Subject: Transmittal of Class 1 Permit Modification to add a Restroom Trailer at TA-54, Pad 11 to the Los Alamos National Laboratory (LANL) Hazardous Waste Facility Permit, EPA ID No. NM0890010515

**Class 1 Permit Modification to Add a Restroom Trailer at
TA-54, Pad 11**

EPC-DO-16-352

LA-UR-16-28796

Figure 36: Technical Area (TA)- 54, Area G, Pad 11

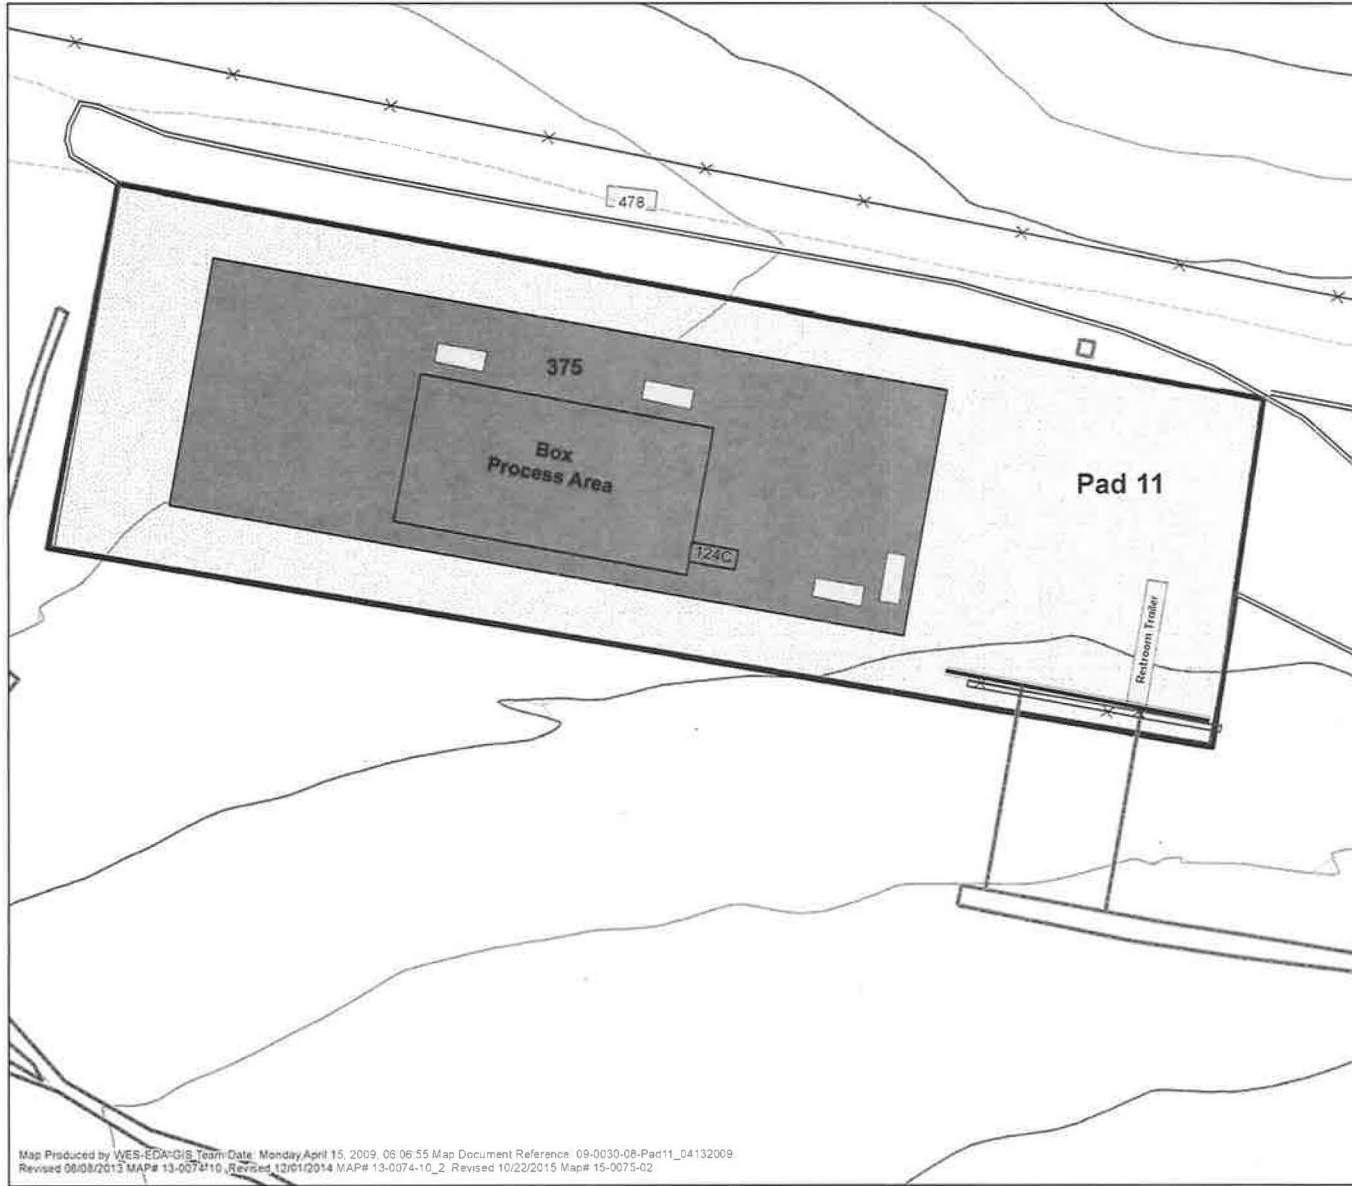
Figure 36, *TA-54, Area G, Pad 11* and Figure G.12, *Technical Area 54, Area G, Pad 11 Outdoor Closure Plan*, were revised to reflect the location of the restroom trailer.
